ARCHITECTURE PLANNING URBAN DESIGN

RE: 15921 Linda Avenue

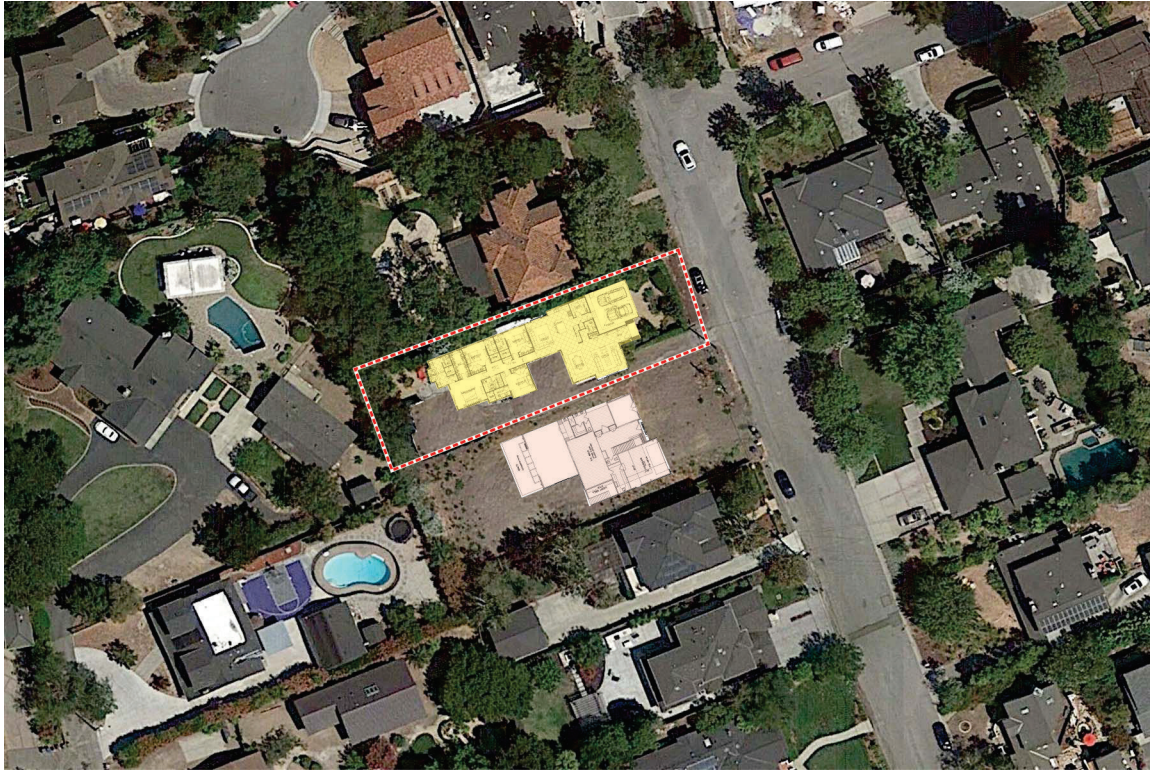
The proposed house has a relatively large footprint compared to others in the neighborhood and the recently approved new home on the adjacent parcel - see illustration below. However, the proposed house would be one-story in height compared to the others which are largely two-stories tall.

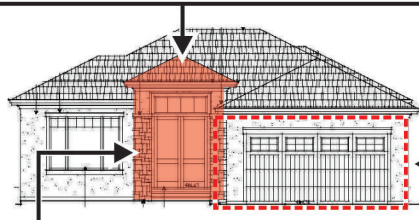
Tall entry is out of character with preponderance of under eave entries in the neighborhood

Stone limited to use on the front elevation is inconsistent with Residential Design Guideline 3.2.2

Projecting garage is inconsistent with Residential Design Guideline 3.4.1

1. The tall entry element is out of character with this neighborhood and is not consistent with Residential Design Guideline 3.6.3.

2. The use of stone on the front elevation without carrying the material around on other facades is not consistent with Residential Design Guideline 3.2.2.

1. Eliminate the stone on the front elevation or carry the stone consistently around all facades of the house.
2. Deep set the garage door.
3. Modify the entry to be more consistent with the norm of the neighborhood by integrating the entry with the garage roof form and providing an under-eave entry similar to others in the neighborhood.

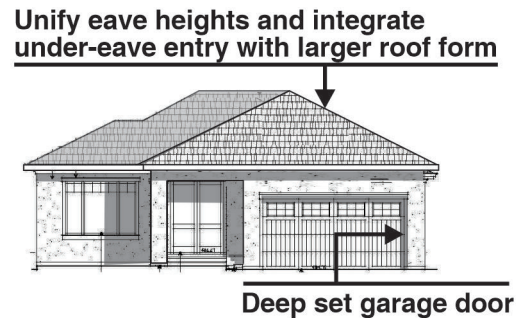
4. The garage projecting in front of the remainder of the house is not consistent with Residential Design Guideline 3.4.1.

While this would not set the garage back, it would align it with the entry, and diminish the appearance of a projecting garage.
